ADDENDUM NO. 4

PROJECT NAME: Outdoor Adventure Center
UNL PROJECT NUMBER: C220P001

CONSULTANT: RDG Planning & Design
ADDRESS: 900 Farnam on the Mall, Suite 100, Omaha, NE 68102

DATE OF ISSUANCE: July 11, 2012
DATE OF BID OPENING: July 16, 2012

SDC-006

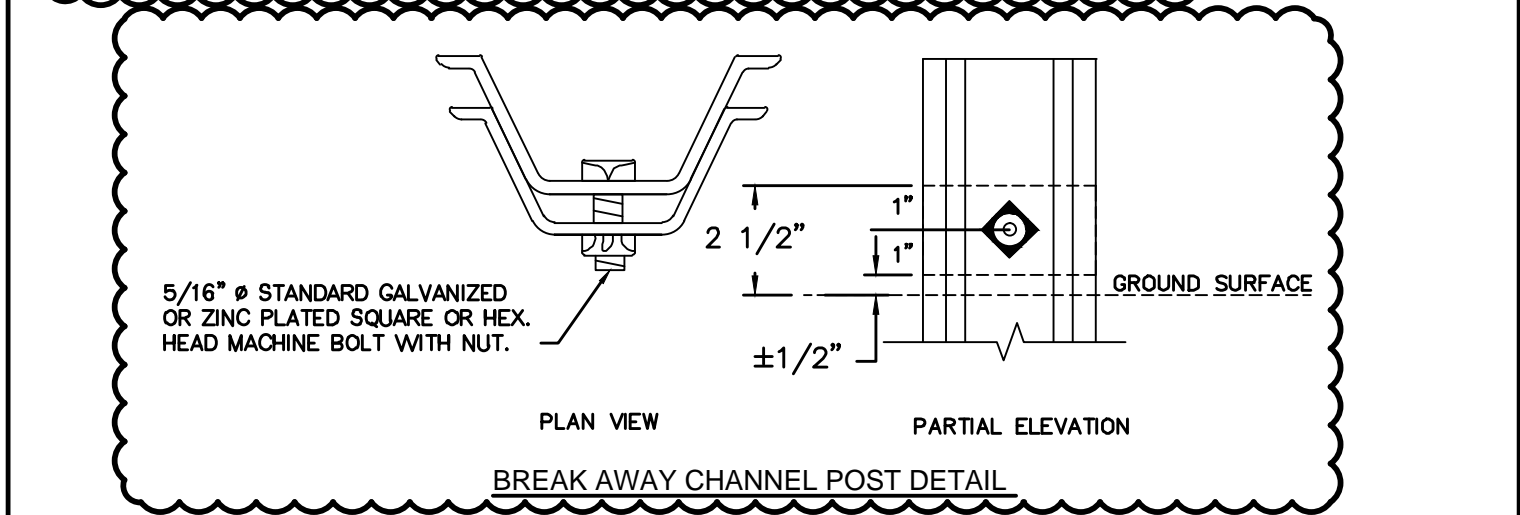
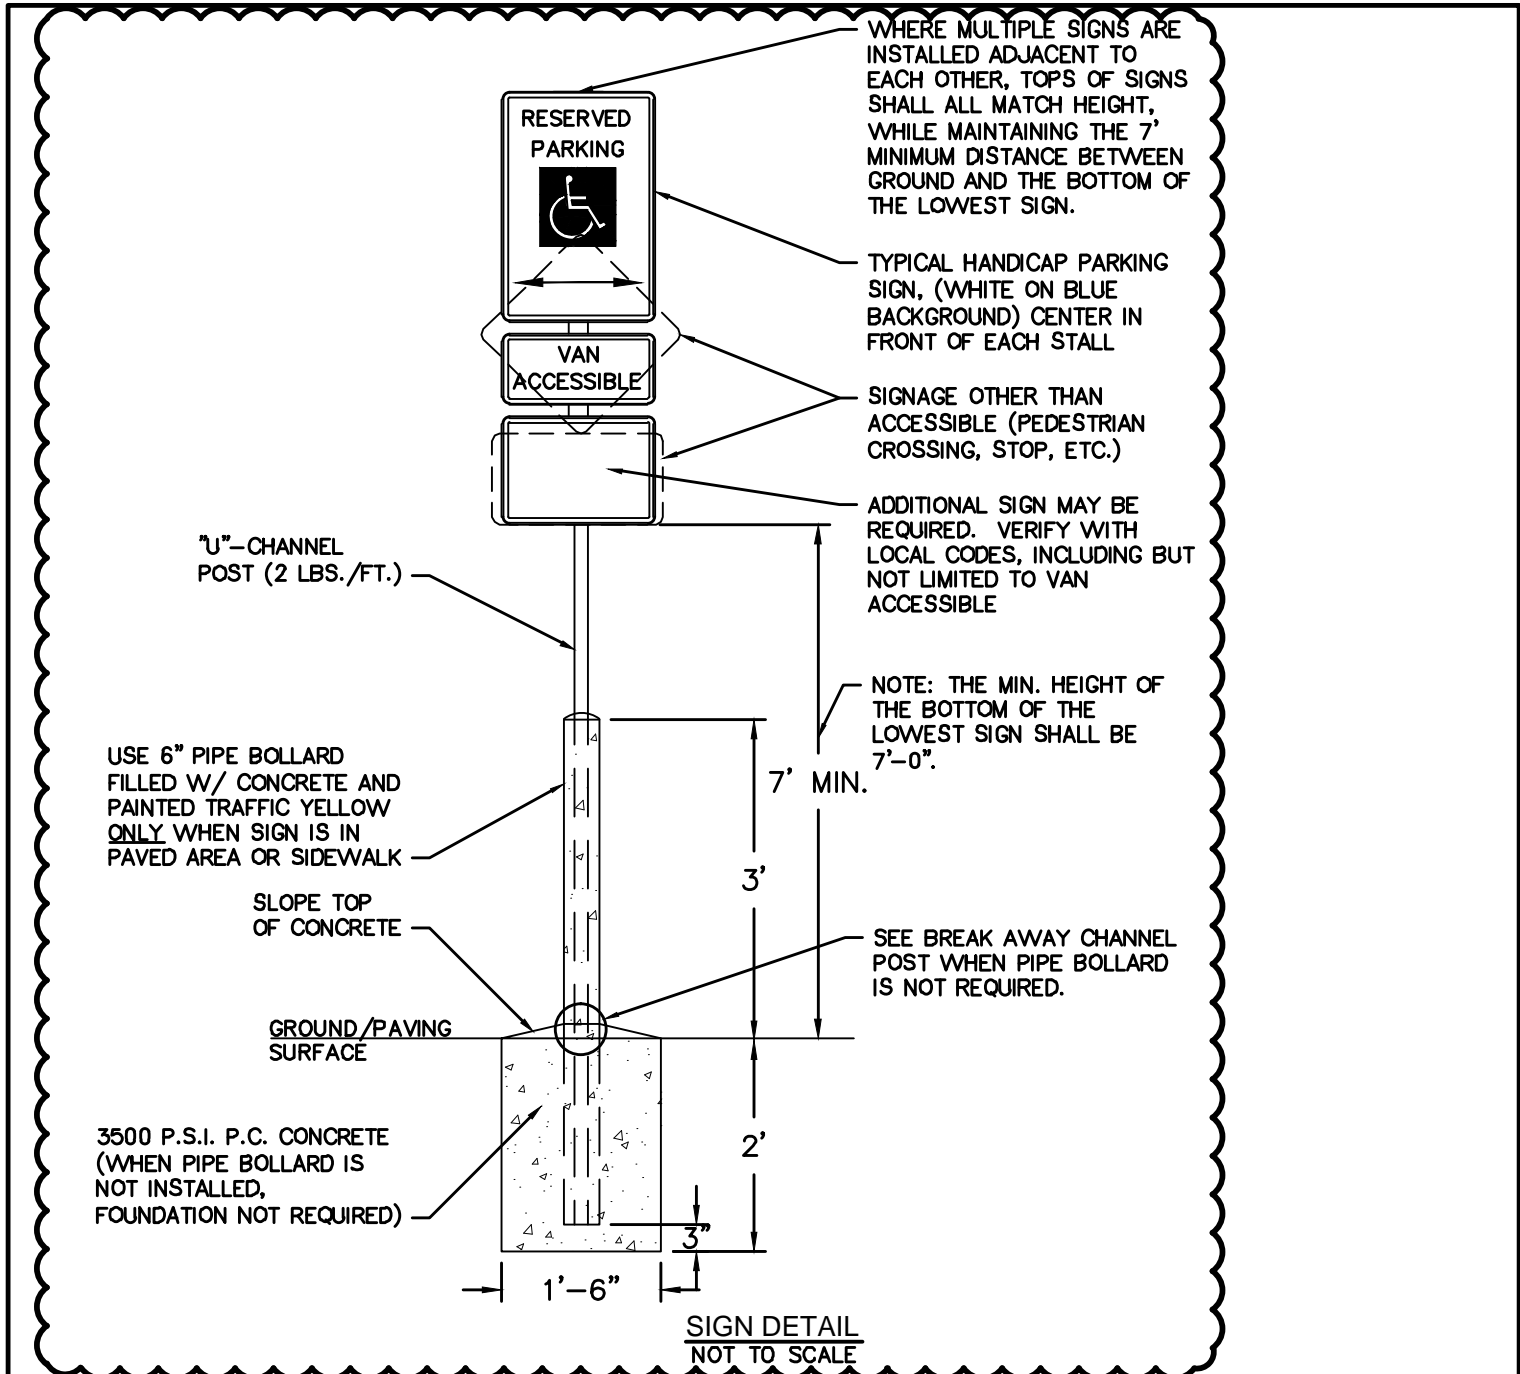
- A. Updated note locations and descriptions. See attached Supplemental Drawing SDC-006.
- B. Included handicapped sign detail. See attached Supplemental Drawing SDC-007.
- C. Included handicapped symbol detail. See attached Supplemental Drawing SDC-008.

2011.182.00
 35.01
 SDA-019

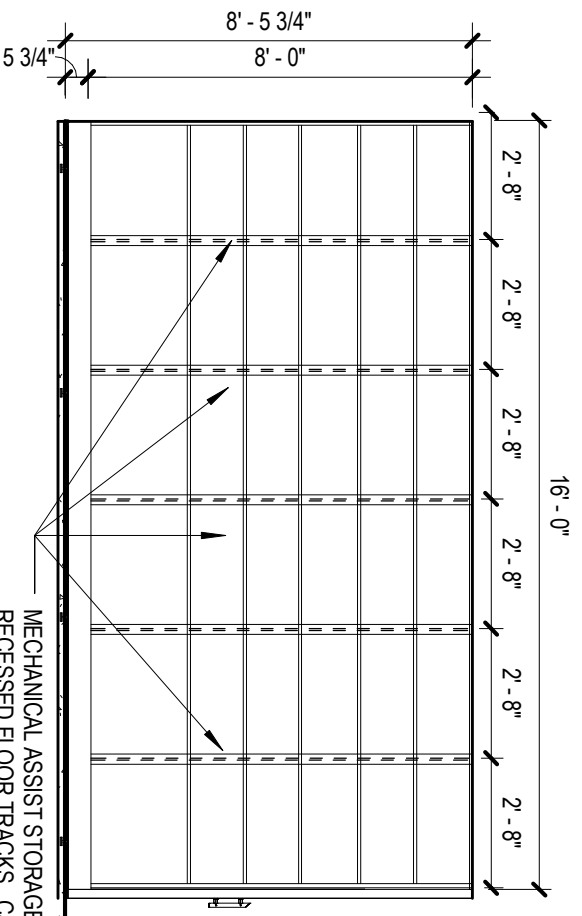
4GD-1 Sheet A1.01 – FIRST FLOOR PLAN: DETAIL 1: Revise per attached Supplemental Drawing SDA-019 and SDA-021.

2011.182.00
 35.01
 SDA-020

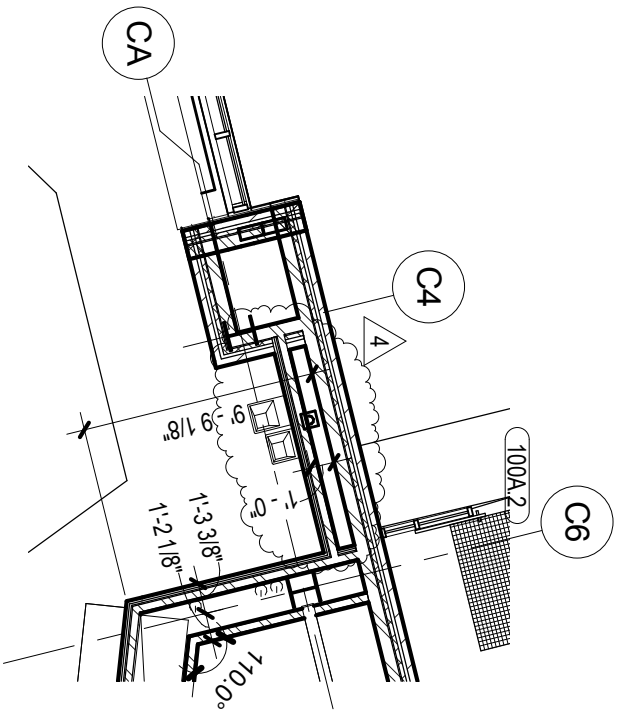
4GD-5 Sheet A13.01 – INTERIOR ELEVATIONS, DETAIL 6: Revise per attached Supplemental Drawing SDA-020.

2011.182.00
 35.01
 SDA-022

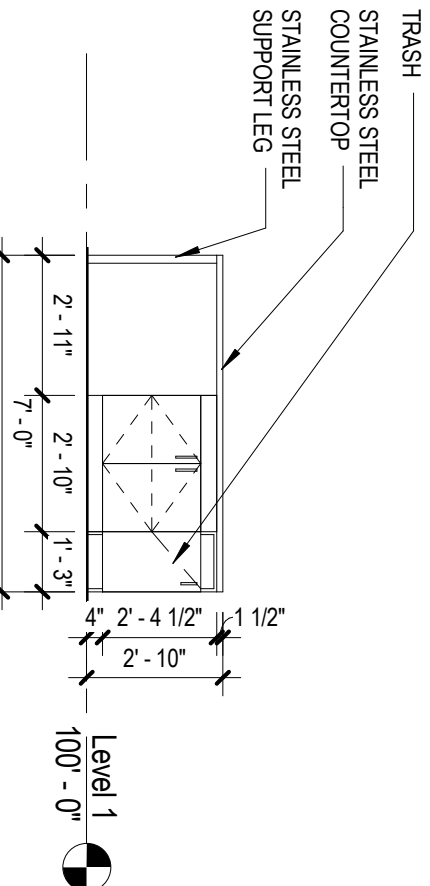
4GD-2 Sheet A2.02 – ENLARGED PLANS, DETAIL 5: Revise per attached Supplemental Drawing SDA-022.

24
1/4" = 1'-0"
FOOD SERVICE FACILITY 103C - ISLAND - NORTH

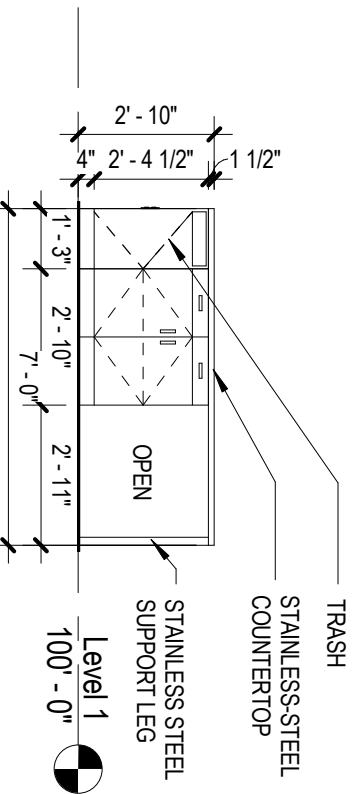
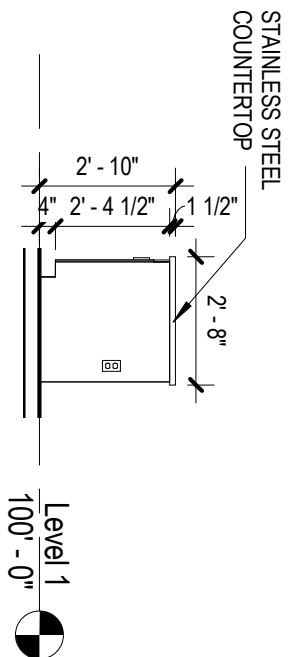
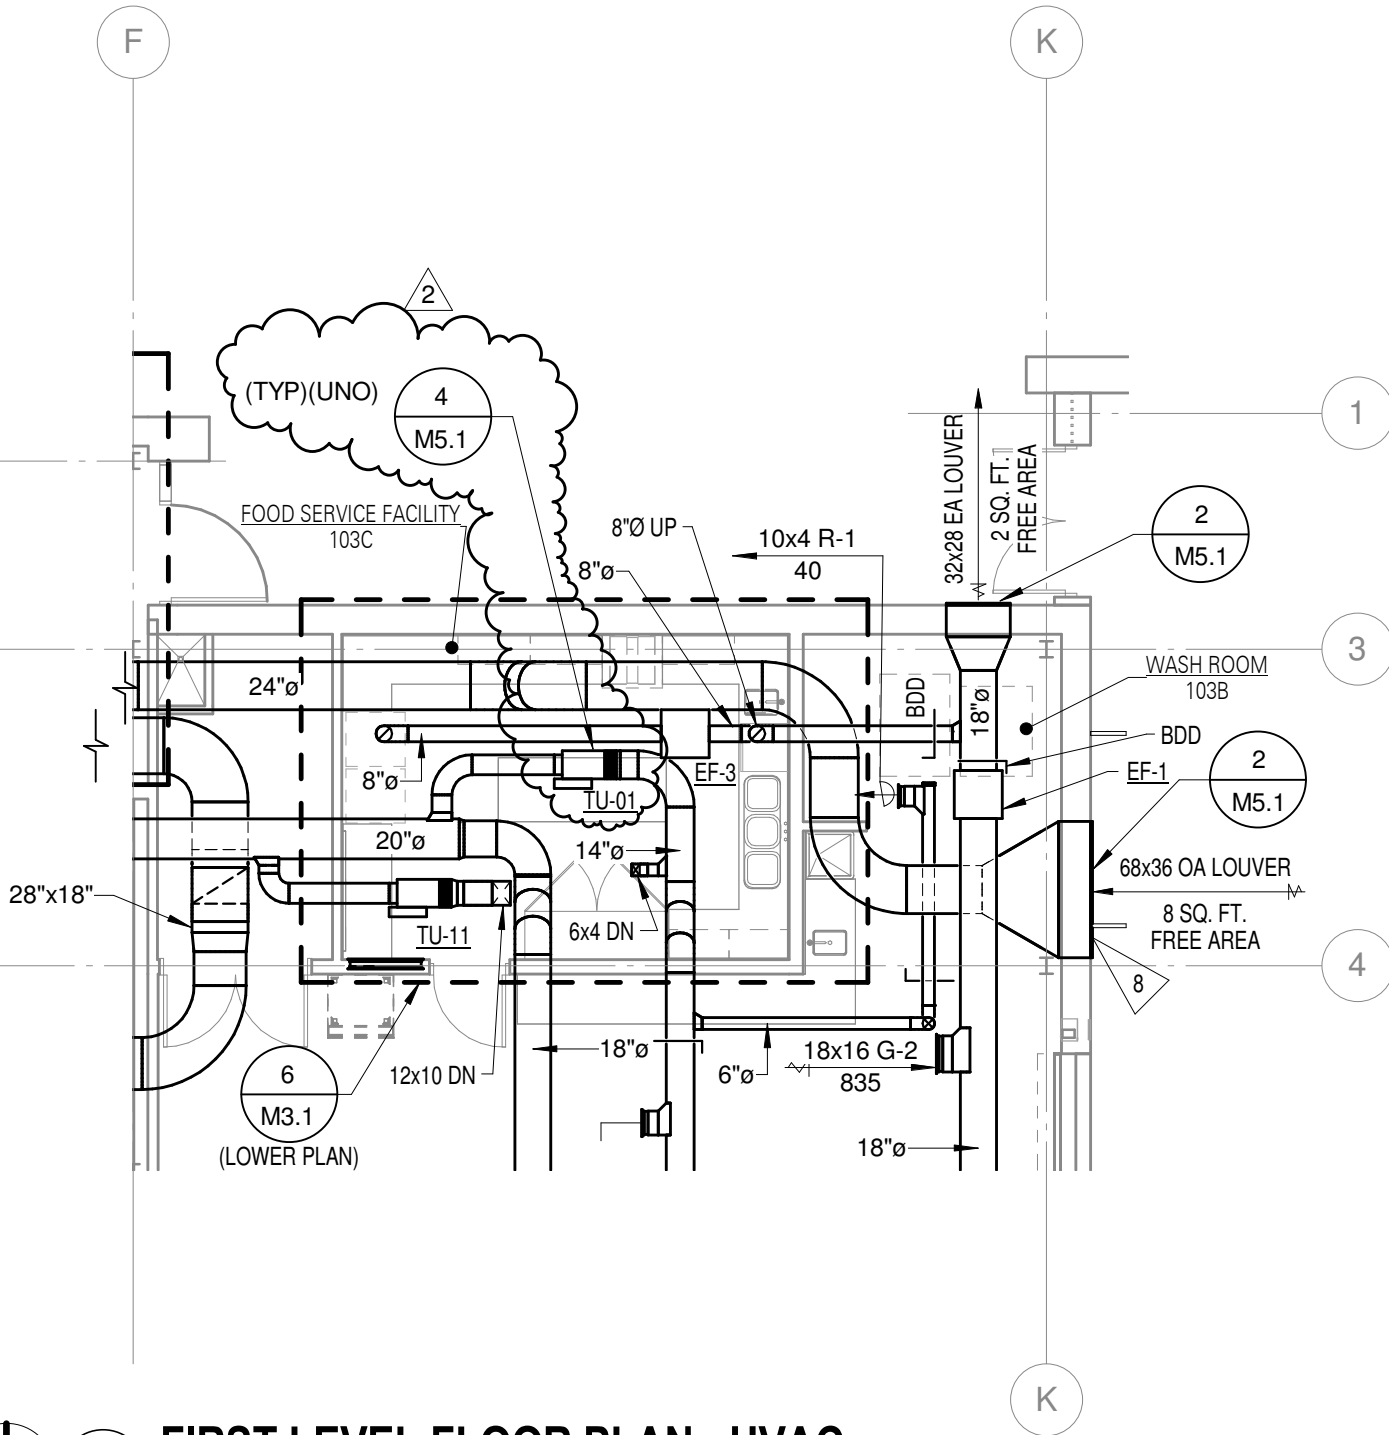
4GD-6 Sheet A13.02 – INTERIOR ELEVATIONS, DETAILS 24, 29, and 30: Revise per attached Supplemental Drawing SDA-023.

2011.182.00
 35.01
 SDM-004

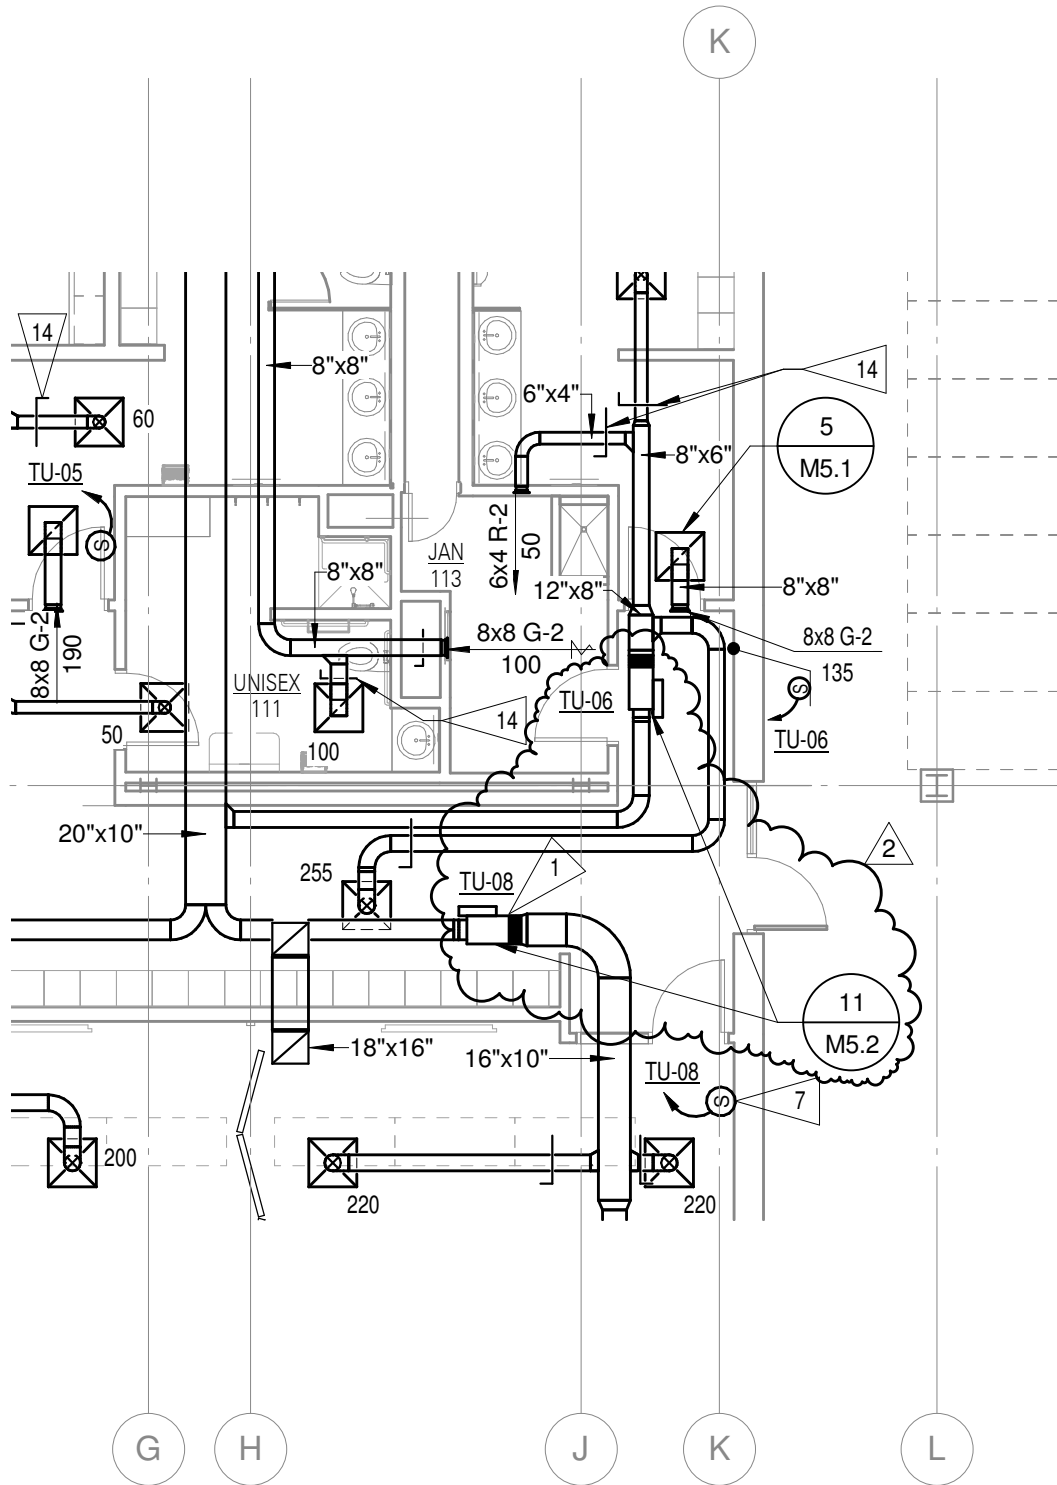
- 4MD-1 Sheet M1.1: Added and updated detail references. See attached Supplemental Drawings SDM-004 and SDM-005.
- 4MD-2 Sheet M2.1: Added and updated detail references. See attached Supplemental Drawing SDM-006.

2011.182.00
35.01
SDM-007

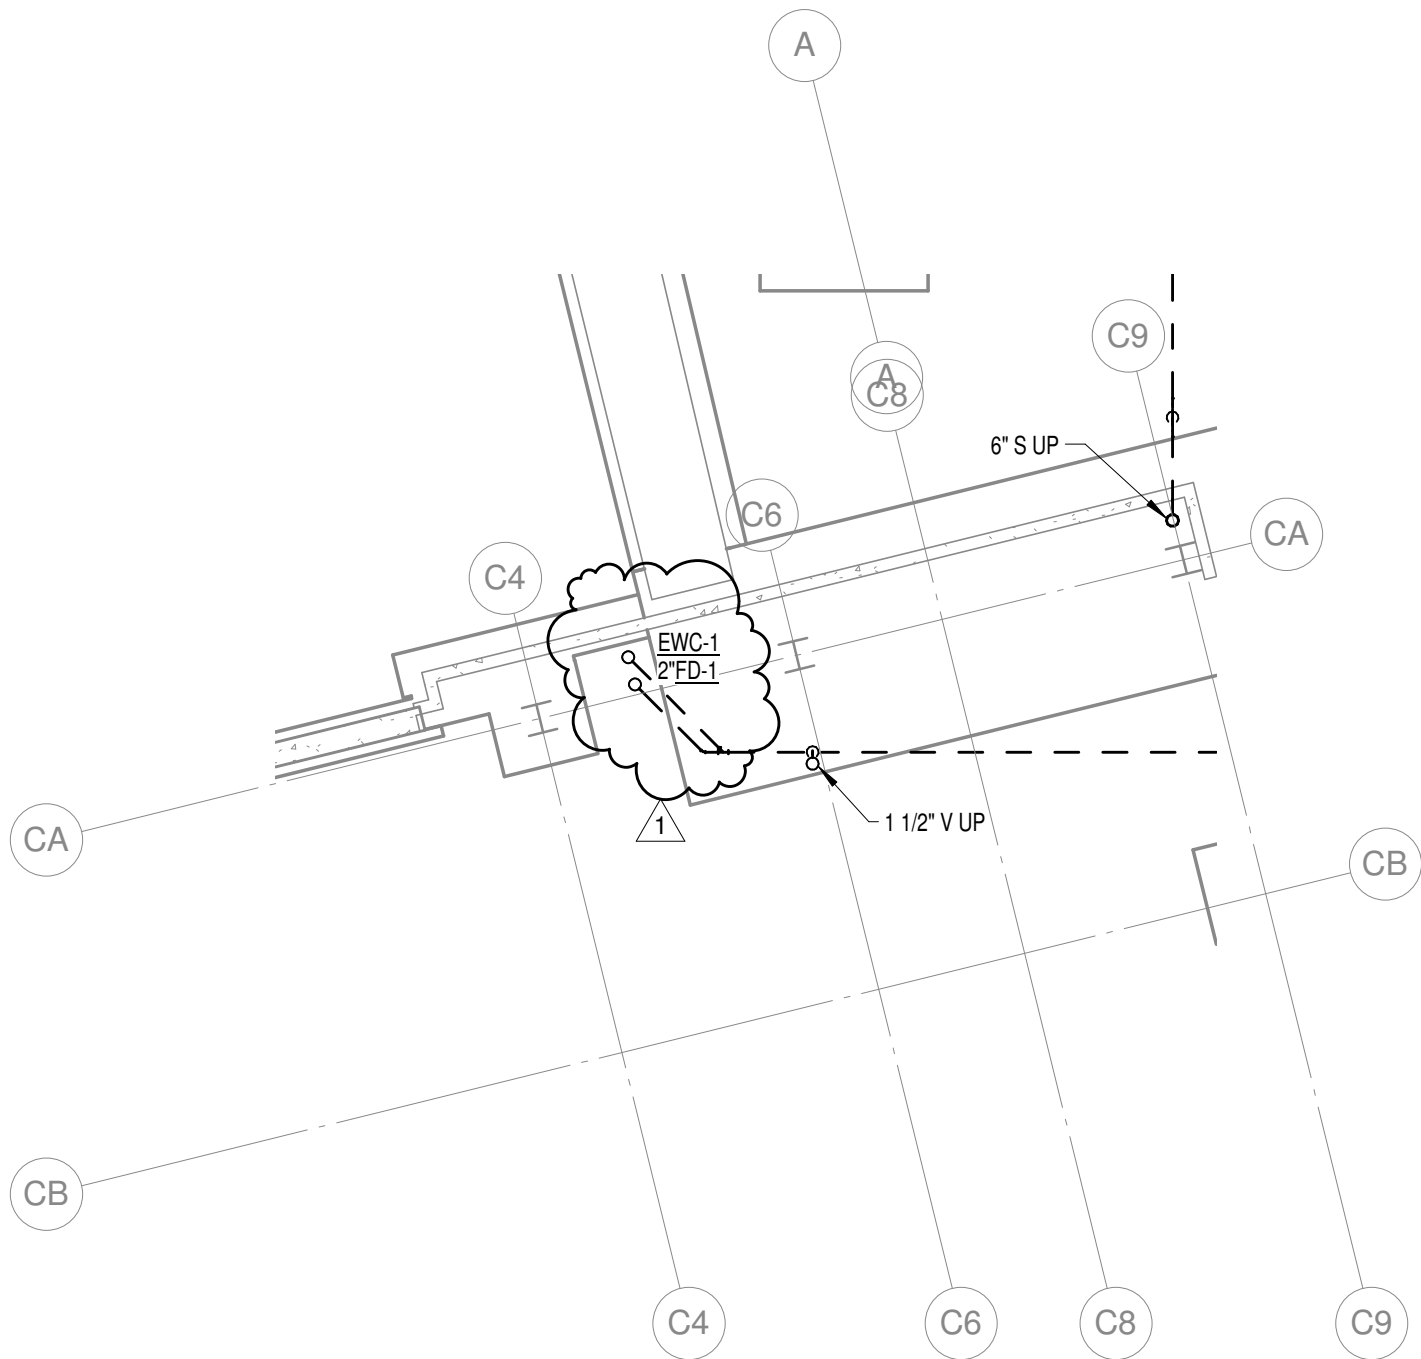
- 4MD-3 Sheet M5.1: Deleted detail references and clarified the control valve note. See attached Supplemental Drawing SDM-007.
- 4MD-4 Sheet M5.2: See attached revised sheet.
